The Narragansett Electric Company
d/b/a National Grid

**Gas Infrastructure,
Safety, and Reliability Plan
FY 2021 Proposal**

**Responses to Division's Data
Requests**

Docket No. 4996

Flood Zone Map in the vicinity of Wood Street and Woodlawn Street, Bristol, RI

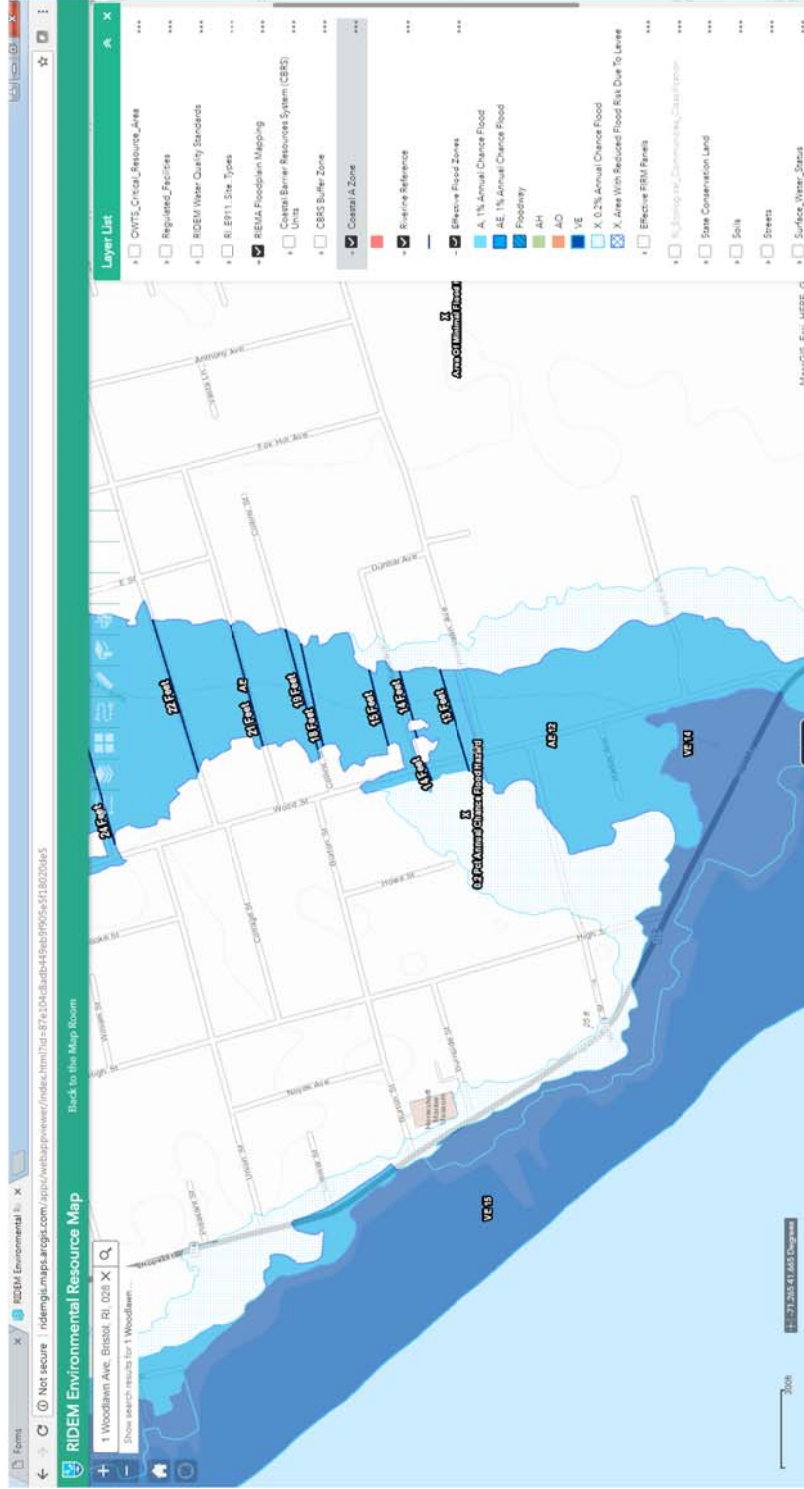
- a) How much of the budget is for the initial phase of a multi-year project at the Cumberland Take station and how much is for Woodlawn regulator station in Bristol, RI?;
- b) Explain the sentence: "Funding is also included for the Wood at Woodlawn regulator station in Bristol which is being completed to move a regulator station out of the flood plain";
- c) Has the station ever flooded?;
- d) What is the risk of the station flooding?; and
- e) Can the station be moved out of the flood plain in a future year? Please explain.

- d) Based on the flood plain map in Attachment DIV 1-5A, the Wood at Woodlawn regulator station is an area that has a 1% annual chance of flooding.
- e) The station could have been moved out of the flood plain in a future year. However, construction began on the project in the third quarter of FY 2020 with the goal of having the new station operational by the Spring of 2020. Previously, the project had been at risk of being deferred to fiscal year 2021 and hence it was included in the 2021 ISR filing.
